NO: SW-092 **PRODUCT:** A22R Series Switches
DATE: April 2016 **TYPE:** Discontinuation Notice

Parts to Build A22R Series Switches are No Longer Available; Immediately Migrate Customers to A22N Series

Body Color

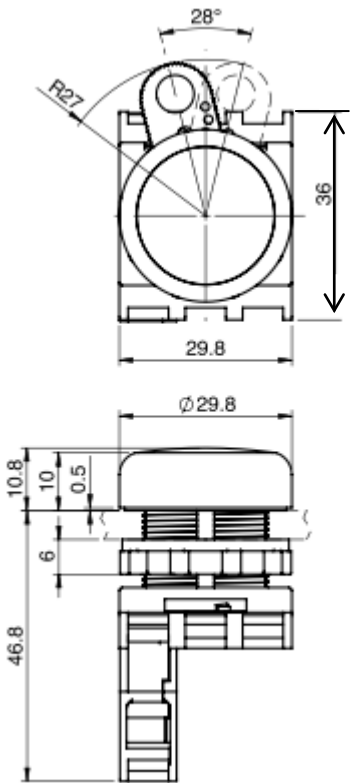
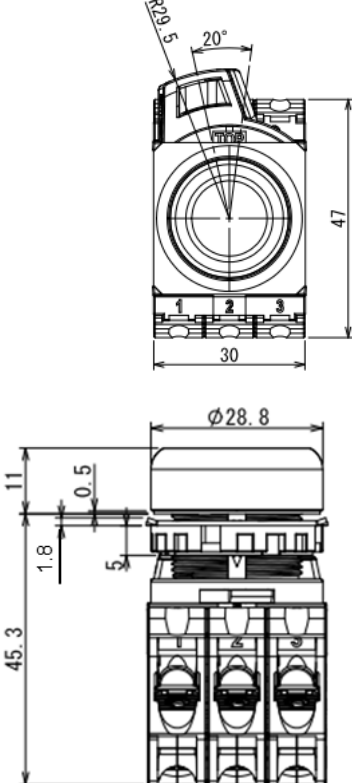
<p align="center">Product discontinuation Model A22R, A22RL series Model A22RS, A22RW series Model A22RK series</p>	<p align="center">Recommended replacement Model A22N, A22NL series Model A22NS, A22NW series Model A22NK series</p>
<p>For example:A22RW series</p> <p>Lever: Red Contact block (NO): Black Contact block (NC): Brown</p> 	<p>For example:A22NW series</p> <p>Lever: Yellow Contact block (NO): Blue Contact block (NC): Orange</p>

Mounting Dimensions

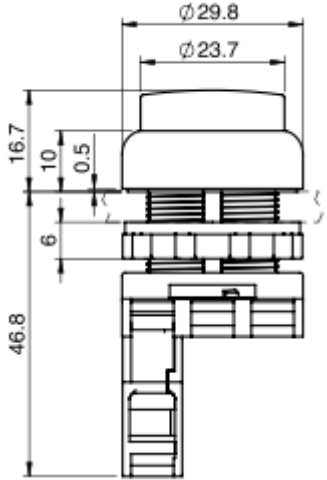
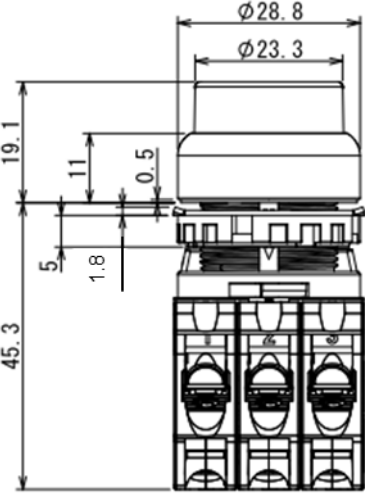
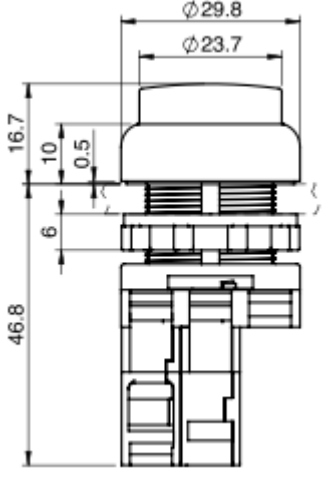
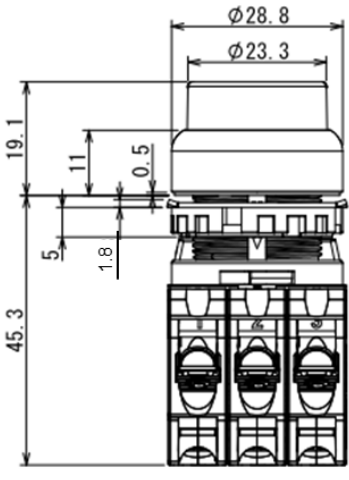
<p align="center">Product discontinuation Model A22R,A22RL series Model A22RS,A22RW series Model A22RK series</p>	<p align="center">Recommended replacement Model A22NN,A22NL series Model A22NS,A22NW series Model A22NK series</p>
<p>Recommended panel thickness: 1 to 5 mm</p> <p>Matrix Installation:</p> <ol style="list-style-type: none"> ① When wire a lead directly (without solderless terminal), or use a standard size nameplate unit, the dimension of "A" shall be more than 45 mm. ② When use solderless terminals without insulator, or mount a large nameplate unit, the dimension of "A" shall be more than 51 mm. ③ When use solderless terminals with insulator, the dimension of "A" shall be more than 60 mm. <div data-bbox="203 756 690 1470" style="text-align: center;"> </div>	<p>Recommended panel thickness: 0.8 to 5 mm</p> <p>Matrix Installation:</p> <ol style="list-style-type: none"> ① When wire a lead directly (without solderless terminal), use solderless terminals without insulator, or use a standard size nameplate unit, the dimension of "A" shall be more than 50 mm. ② When mount a large size nameplate unit, the dimension of "A" shall be more than 51 mm. ③ When use solderless terminals with insulator, the dimension of "A" shall be more than 60 mm. ④ B dimensions, Mushroom type pushbutton switch more than 40mm, otherwise more than 30mm. <div data-bbox="933 745 1404 1459" style="text-align: center;"> </div>

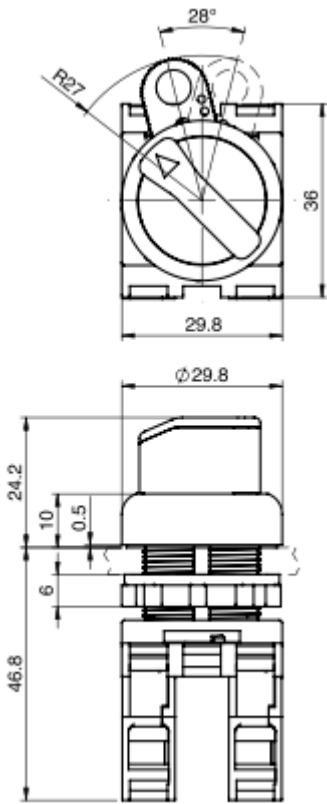
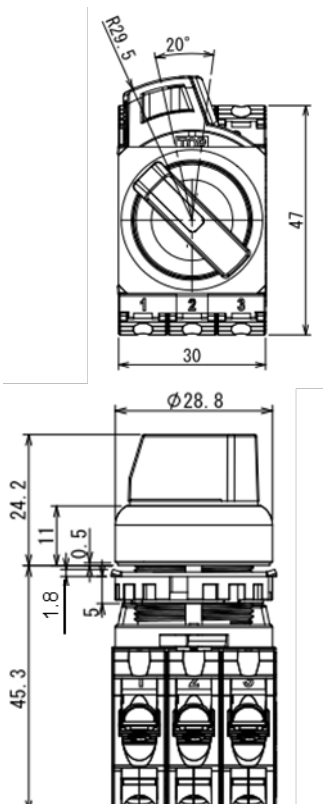
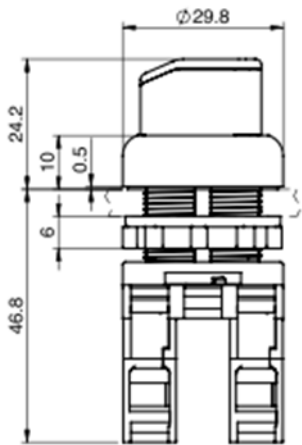
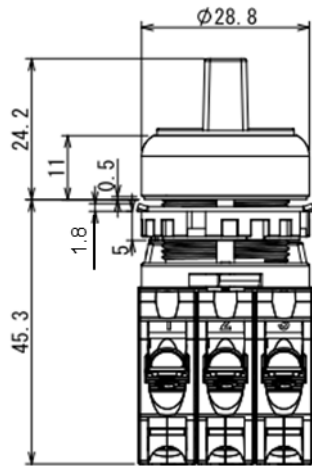
Product discontinuation Model M22R series	Recommended replacement Model M22N series
<p>Recommended panel thickness: 1 to 5 mm</p> <p>Matrix Installation:</p> <p>① When wire a lead directly (without solderless terminal), or use a standard size nameplate unit, the dimension of "A" shall be more than 45 mm.</p> <p>② When use solderless terminals without insulator, or mount a large size nameplate unit, the dimension of "A" shall be more than 51 mm.</p> <p>③ When use solderless terminals with insulator, the dimension of "A" shall be more than 60 mm.</p> 	<p>Recommended panel thickness: 0.8 to 6 mm</p> <p>Matrix Installation:</p> <p>① When wire a lead directly (without solderless terminal), or use solderless terminals without insulator, or use solderless terminals with insulator, the dimension of "A" shall be more than 30 mm.</p>

Dimensions

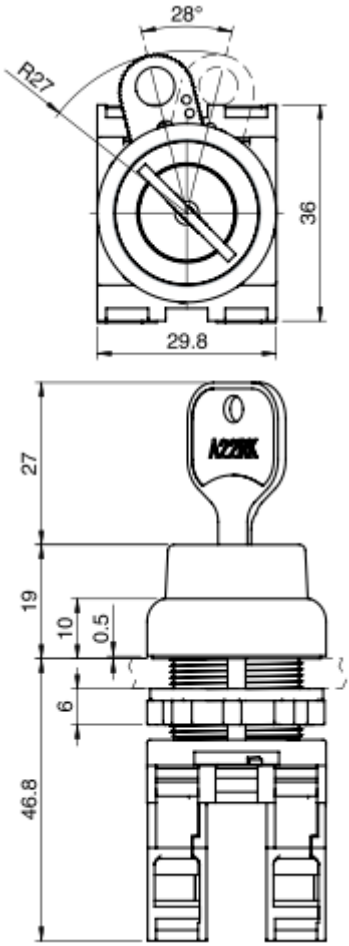
Product discontinuation Model A22R, A22RL series	Recommended replacement Model A22NN, A22NL series
<p>A22R-F□ series</p> 	<p>A22NN-RN□ series</p>

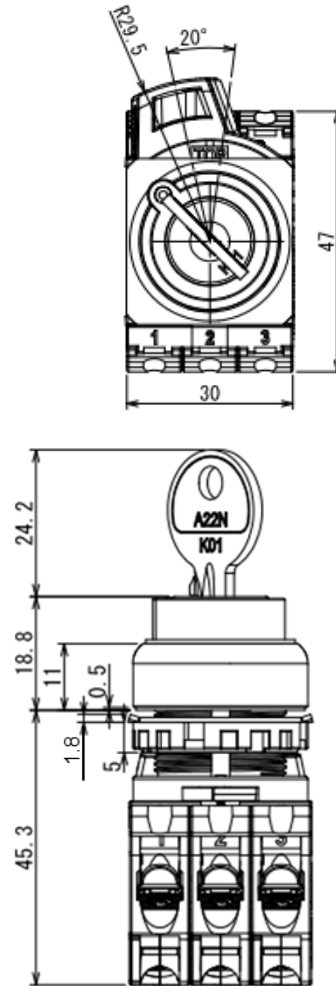
<p align="center">Product discontinuation Model A22R, A22RW series</p>	<p align="center">Recommended replacement Model A22NS, A22NW series</p>
<p>A22RS-2□ series A22RW-2□ series</p> 	<p>A22NS-2R□ series A22NW-2R□ series</p> 
<p>A22RS-3□ series A22RW-3□ series</p> 	<p>A22NS-3R□ series A22NW-3R□ series</p>

**Product discontinuation
Model A22RK series**

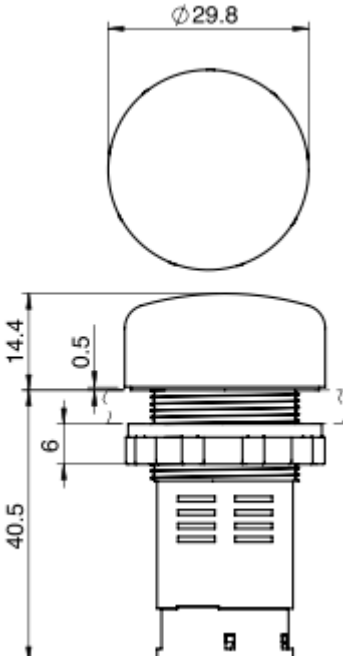
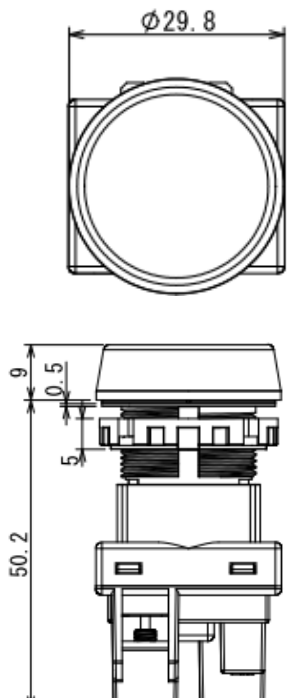
A22RK-2□ series
A22RK-3□ series

A22NK-2R□ series
A22NK-3R□ series

Characteristics

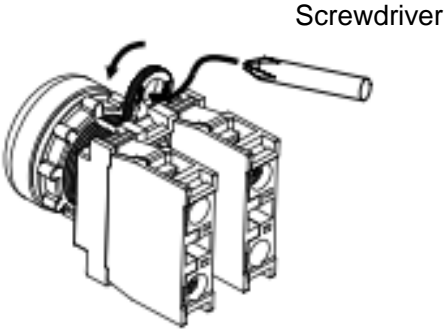
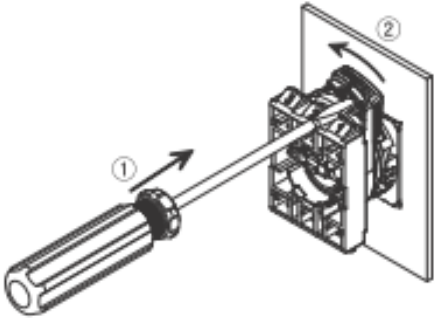
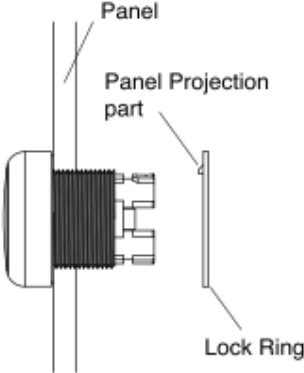
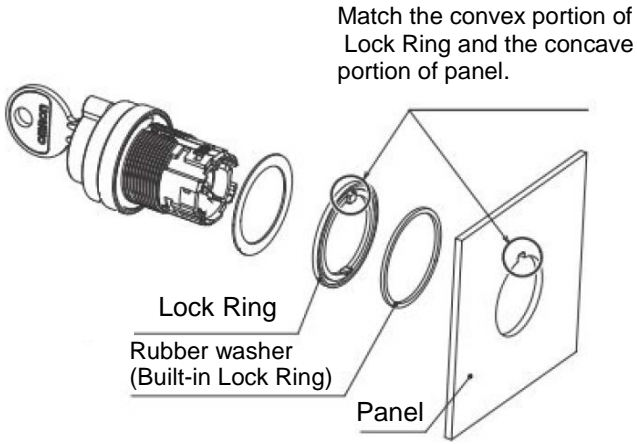
Characteristics	Pushbutton Switch Model A22R,A22RL series	Selector Switch Model A22RS,A22RW series		Key-type selector Switch Model A22RK series	
		Manual reset	Auto reset	Manual reset	Auto reset
Total travel force TTF max.	29.4 N	0.34 N · m	2-notch: 0.24 N · m 3-notch: 0.34 N · m	0.34 N · m	2-notch: 0.24 N · m 3-notch: 0.34 N · m
Releasing force RF max.	--	0.34 N · m	--	0.34 N · m	--
Total travel TT	5.5 mm max.	2-notch: Approx.90 degree 3-notch: Approx.45 degree	2-notch: Approx.90 degree 3-notch: Approx.45 degree	2-notch: Approx.90 degree 3-notch: Approx.45 degree	2-notch: Approx.90 degree 3-notch: Approx.45 degree

Characteristics	Pushbutton Switch Model A22N,A22NL series	Selector Switch Model A22NS,A22NW series		Key-type selector Switch Model A22K series	
		Manual reset	Auto reset	Manual reset	Auto reset
Total travel force TTF max.	18 N	0.6 N · m	2-notch: 0.6 N · m 3-notch :0.6 N · m	0.6 N · m	2-notch: 0.6 N · m 3-notch :0.6 N · m
Releasing force RF max.	--	0.5 N · m	--	0.5 N · m	--
Total travel TT	6 mm max.	2-notch: Approx.90 degree 3-notch: Approx.45 degree	2-notch: Approx.90 degree 3-notch: Approx.45 degree	2-notch: Approx.90 degree 3-notch: Approx.45 degree	2-notch: Approx.90 degree 3-notch: Approx.45 degree

Removing the Switch

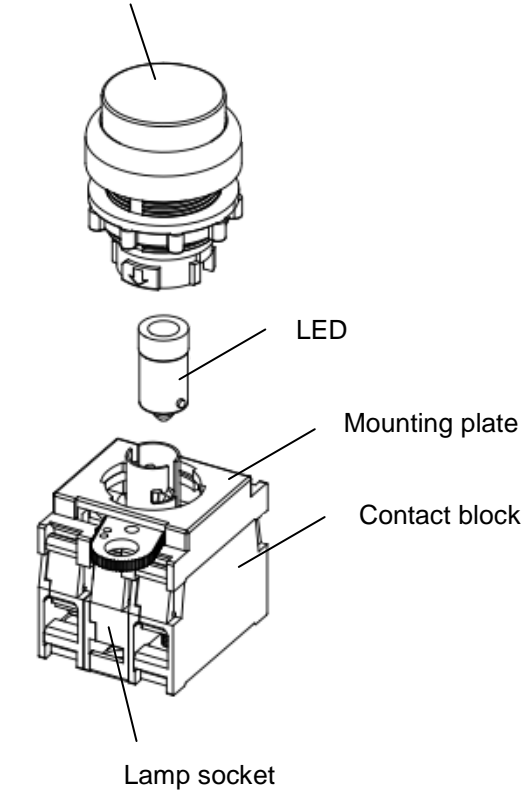
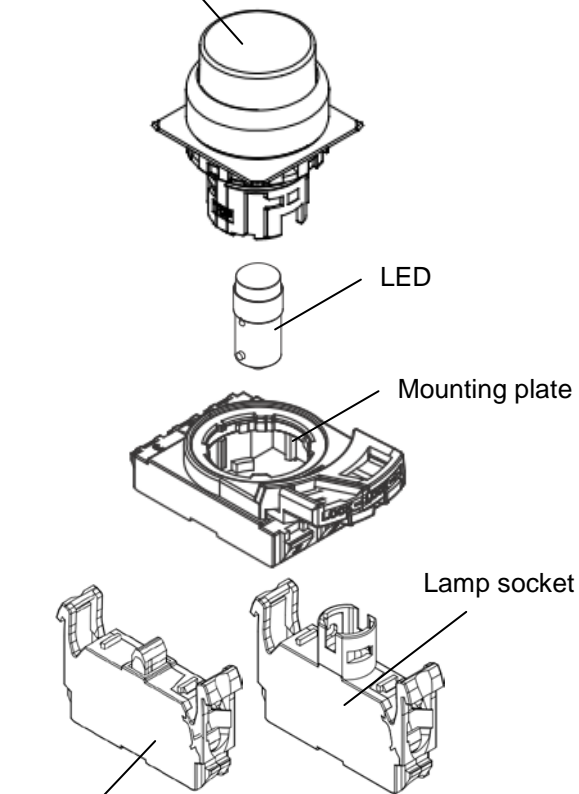
<p>Product discontinuation Model A22R,A22RL series Model A22RS,A22RW series Model A22RK series</p>	<p>Recommended replacement Model A22NN,A22NL series Model A22NS,A22NW series Model A22NK series</p>
<p>•Move the lever in the direction indicated by the arrow in the following figure then pull the Pushbutton Unit or the Switch Blocks.</p> <p>•Since the lever has a hole with an inside diameter of 6.5mm, the lever can be moved in the specified direction by inserting a screwdriver into the hole and then moving the screwdriver.</p>  <p style="text-align: center;">Screwdriver</p>	<p>① Use the Phillips screwdriver to PUSH part in the Mounting plate.</p> <p>② Remove the Switch Blocks by releasing the lock turn to the left.</p>
